Georgia Power Company
40 Inverness Center Parkway
Post Office Box 1295
Birmingham, Alabama 35201
Telephone 205 877-7122

LCV-0210-B

VOGTLE ELECTRIC GENERATING PLANT
DIFFERENTIAL SETTLEMENT OF BURIED PIPE ADDITIONAL INFORMATION

ENCLOSURE 1

Project	125TLE NUCLEAR PLANT, UNIT-1	Prepared By	L R Porel	Date	3-16-92
Subject/Title	PIPE STRESS EVALUATION	Reviewed By	<i>James Smith</i>	Date	3-23-92
		Calculation Number	K5-1202-029-06	Sheet	5A of 5

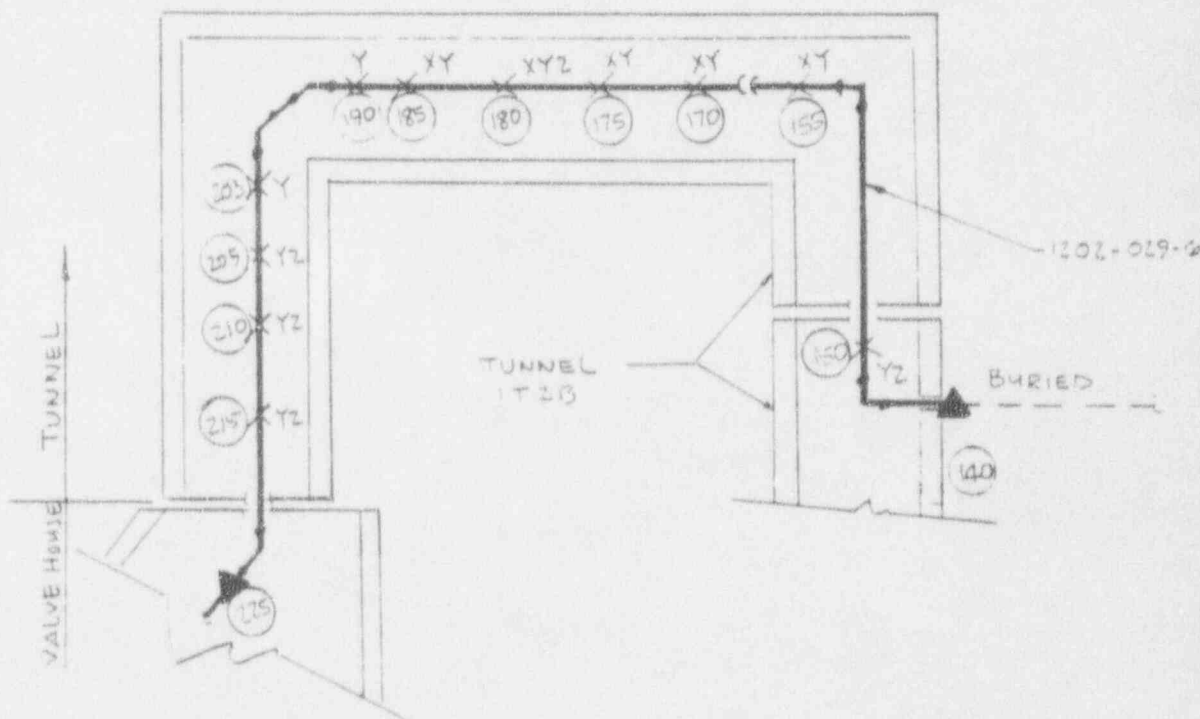
PURPOSE:- TO EVALUATE THE PIPING INTEGRITY PER BUILDING SETTLEMENT MONITORING PROGRAM (CONSIDER $\pm .5"$ DIFFERENTIAL BUILDING SETTLEMENT AT TUNNEL/SOIL)

- 1) TUNNEL (IT2B) / SOIL PENETRATION (BURIED) $\approx .5"$
- 2) TUNNEL (IT2B) / TUNNEL (IT2B) $\approx -0.3"$
- 3) TUNNEL (IT2B) / VALVE HOUSE $\approx -0.5"$

AS A CONSERVATIVE CASE (WORST CASE) BUILDING SETTLEMENT DISPLACEMENTS ARE CONSIDER AT N.P 150 = $-.5''$ AND AT N.P 225 = $-.5''$

$$\text{MAX PIPE STRESS} = 14510 \text{ PSI} < 3S_c = 3 \times 15700 = 47100 \text{ PSI}$$

$$\therefore \text{INTERACTION} = 14510/47100 \approx .31$$

CONCLUSION: THE ANALYSIS HAS BEEN REVIEWED AT REVISED DIFFERENTIAL BUILDING SETTLEMENT CONDITION AND FOUND SATISFACTORY FOR $.5''$ INLIEU OF $.3''$ AT TUNNEL / SOIL INTERFACE.
